Dynasty Sweaters (BD) Ltd Dynasty Knit Fashion Ltd

Aukpara, Ashulia, Savar, Dhaka
(23.878640, 90.297237)
16th March 2014

Observations

4 (Ground Floor, Grid F1 to J1)

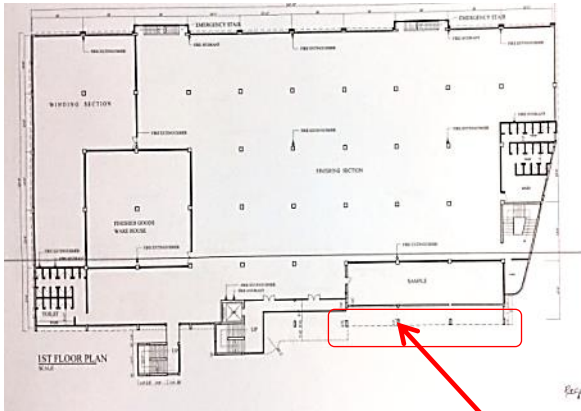
Slender columns at front of building

Engineering drawing showed column as 300mm wide.

Removal of render suggests as built column of 255mm wide.

Edge column:
Apparent lack of verticality

- Building Engineer to investigate extent of large stone in column cover zone. Remove render/ concrete in location of crack and repair as advised by Engineer.
- Confirm actual column dimensions by removal of render locally on all faces.
- Measure verticality of all columns double storey columns.
- Building Engineer to commence checking design of all double storey height columns taking account of verticality, actual dimensions, reinforcement and loads.

5 (Ground Floor, Grid F1 to J1)

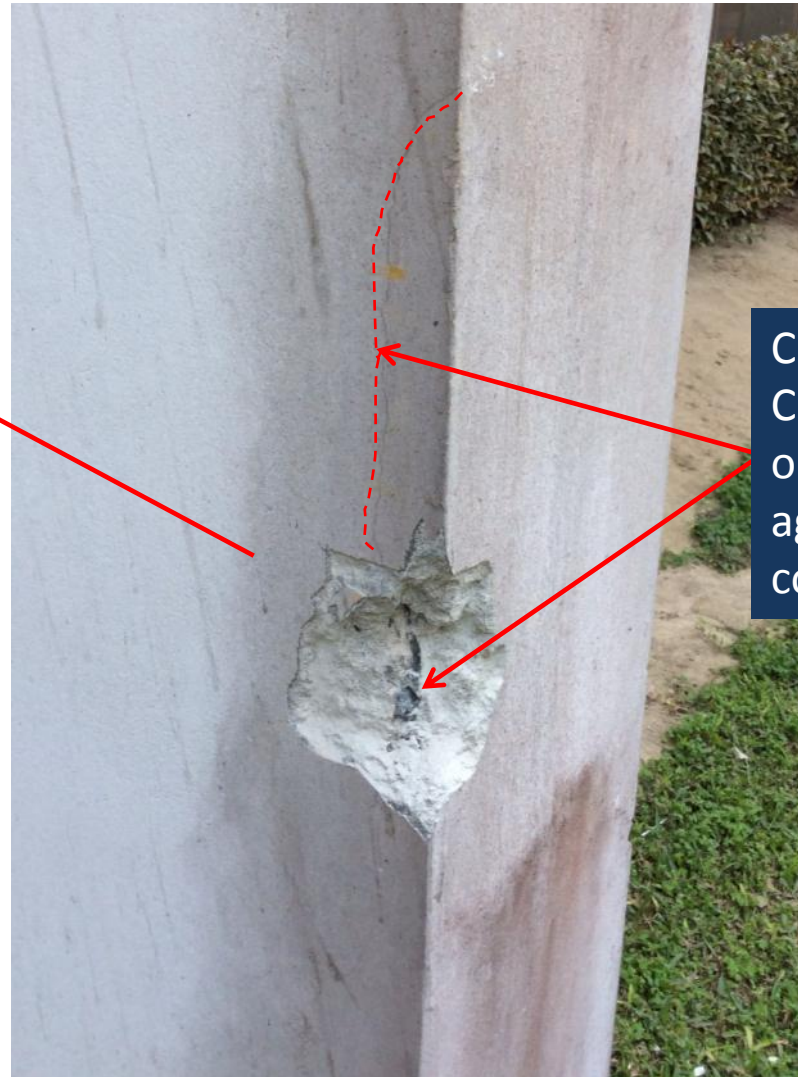
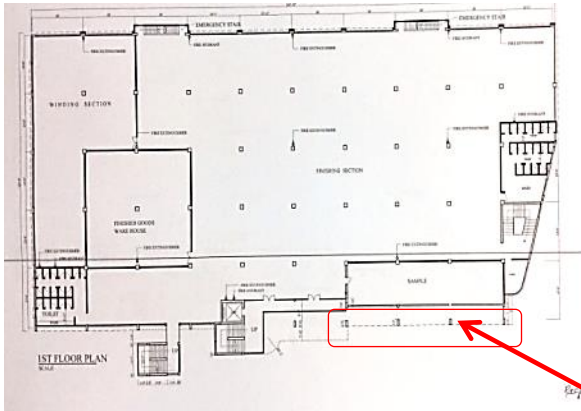
Crack in render.
Closer inspection
observed large
aggregate and poor
concrete.

Column stresses

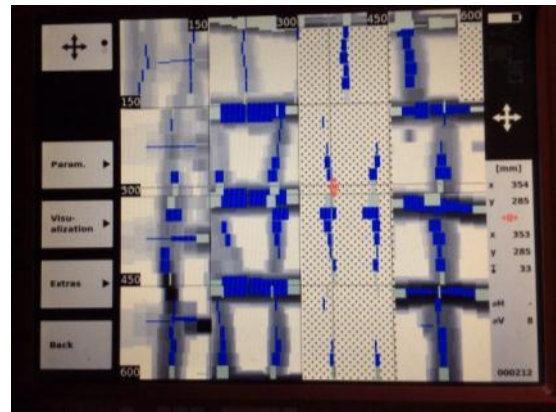
Ferroskans indicate 6 bars in each face, i.e 22 in total

Columns are highly stressed. Engineering drawings show stone aggregate and a high % of reinforcement.

Stone aggregate was confirmed during visit.

No cylinder strength results from construction were available to verify the concrete strength.

The high density of reinforcement could not be conclusively confirmed by the ferroskaner.

- **Create controlled loading plans for all floors**, designating where storage can be placed and can not be placed.
- **Provide calculations showing the structural adequacy of all columns**, taking into account the loading plans and all built structure including additions beyond the original design. Provide concrete strength tests.

Column stresses

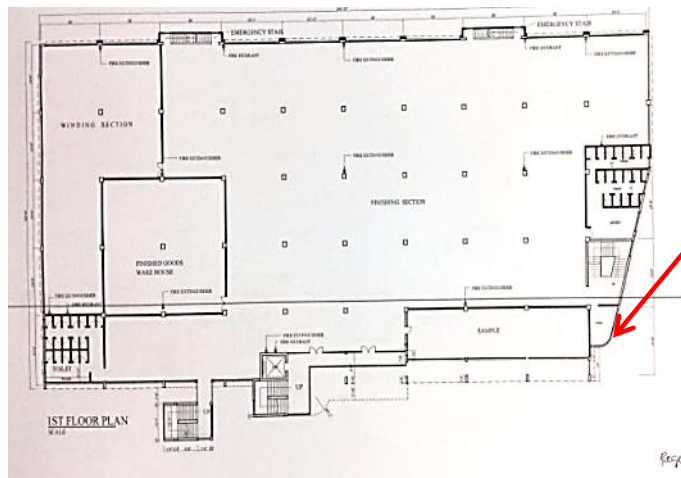
Columns are highly stressed. Engineering drawings show stone aggregate and a high % of reinforcement.

Stone aggregate was confirmed during visit.

No cylinder strength results from construction were available to verify the concrete strength.

The high density of reinforcement could not be conclusively confirmed by the ferros scanner.

Corner Column (Grid J'1) is not shown in the drawings

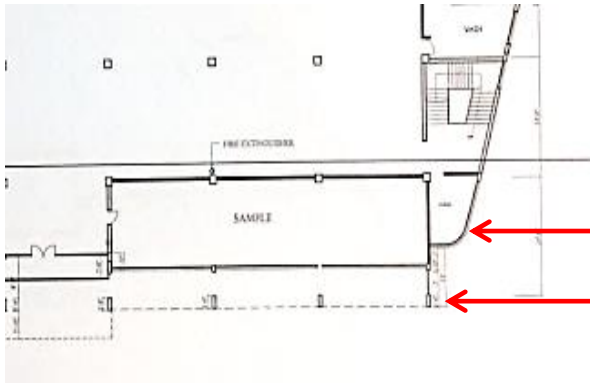
Column was not shown on engineering drawings.

Connection to upper beam/slab and foundation unknown.

Cracking in the brick walls supported by the slab was consistent with cantilevering deflections and therefore the effectiveness of the column is unclear.

Column is also in loading bay so is at risk of vehicle impact.

- Building engineer to produce as-built information for column confirming connection to slab over and foundation detail.
